GE Energy

MFN 06-429
Supplement 2

**Subject: Response to Portion of NRC Request for Additional Information
Letter No. 59 Related to ESBWR Design Certification Application -
ESBWR Probabilistic Risk Assessment - RAI Numbers 19.5-3 S02
thru 19.5-14 S02**

**ESBWR Probabilistic Risk Assessment
RAI Numbers 19.5-3 S2, 19.5.4 S2, 19.5-5 S2, 19.5-6 S2,
19.5-7 S2, 19.5-8 S2, 19.5-9 S2, 19.5-10 S2, 19.5-11 S2,
19.5-12 S2, 19.5-13 S2 and 19.5-14 S2**

Figure 19.5-13 (1) Comparison of Design Ground Spectrum with Soil and Rock Spectra

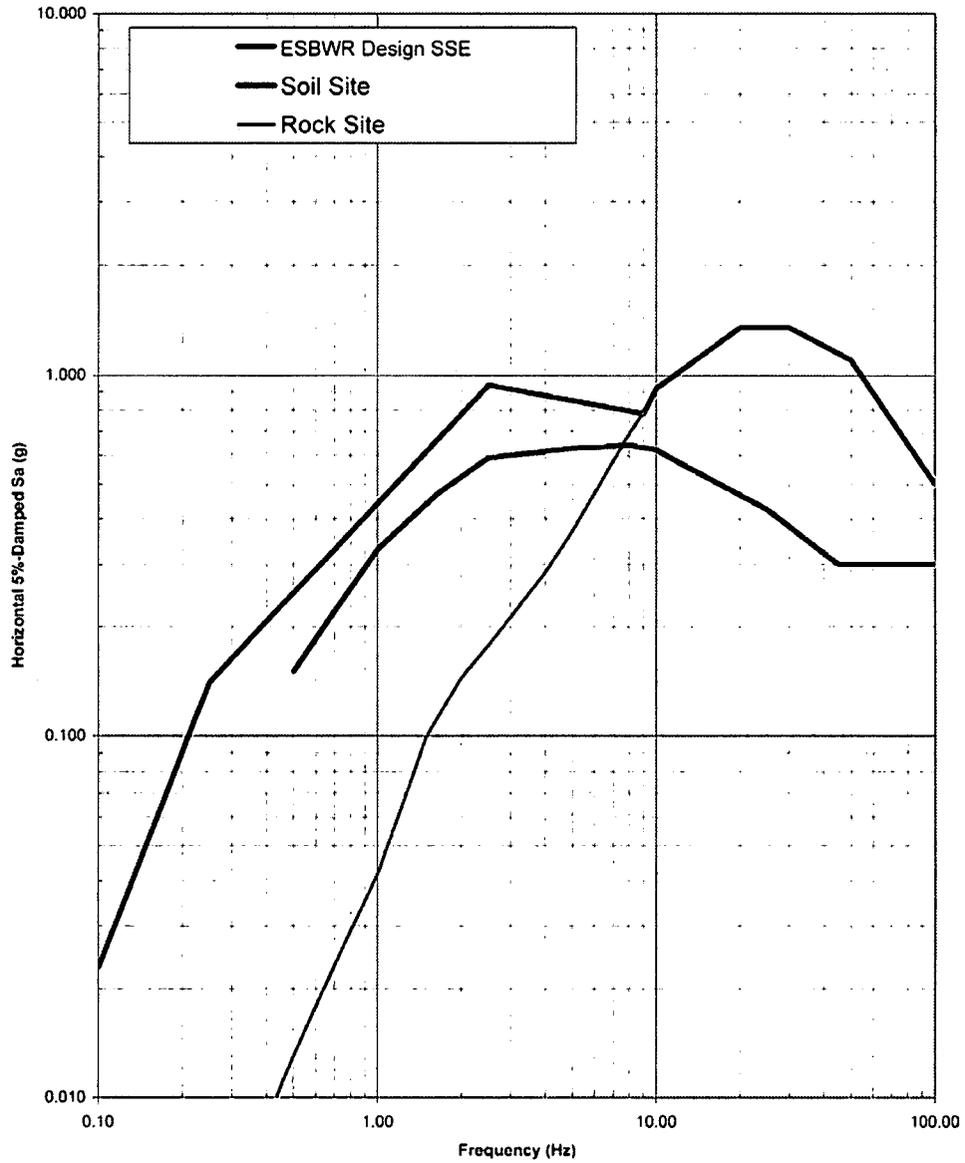
For the shape factor (Fsa), Section 15.3.3.1.2 of NEDO-33201, Rev. 1, states that for the purpose of seismic risk assessment, the median ground motion spectrum given in NUREG/CR-0098, "Development of Criteria for Seismic Review of Selected Nuclear Power Plants," is considered to be the realistic input ground motion definition. Considering the significant number of advancements in the field of seismic hazards since the development of this spectrum in the late 1970's, justify your consideration of the NUREG/CR-0098 spectrum as realistic input ground motion.

The spectral shape factors are reevaluated for two site conditions: rock and soil. For rock sites, the North Anna ESP site SSE spectrum is compared to the ESBWR single envelope design spectrum to determine the shape factor. For soil sites, the bounding SSE spectrum of soil sites among the 28 sites (excluding Vogtle) included in the current EPRI study (Reference 19.5-13(1)) is compared to the ESBWR single envelope design spectrum to determine the shape factor. Figure 19.5-13(1) shows this spectra comparison.

Figure 19.5-13 (2) Comparison of 5% Damped Single Envelope Design Ground Spectrum with Performance-Based Seismic Design Spectrum

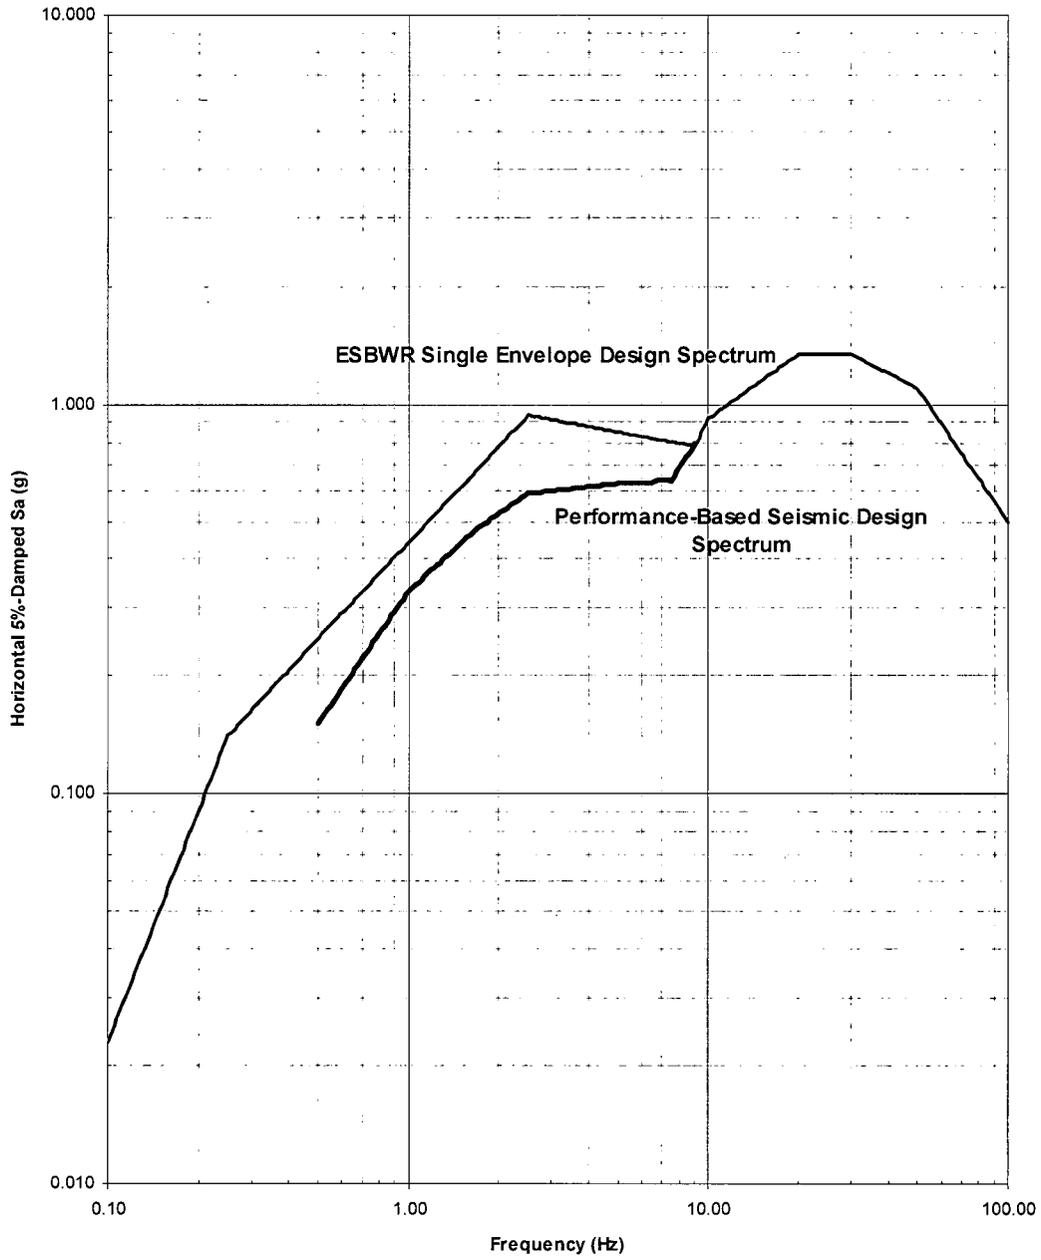
This supplemental response is made for consistency with the issues addressed in RAIs 19.2-43 S2, 19.2-66 S2, 19.2-67 S2 and 19.2-68 S2 as discussed in the February 5, 2007 audit.

NEDO-33201 Section 15.3 will be revised in the next update as noted in the attached markup.
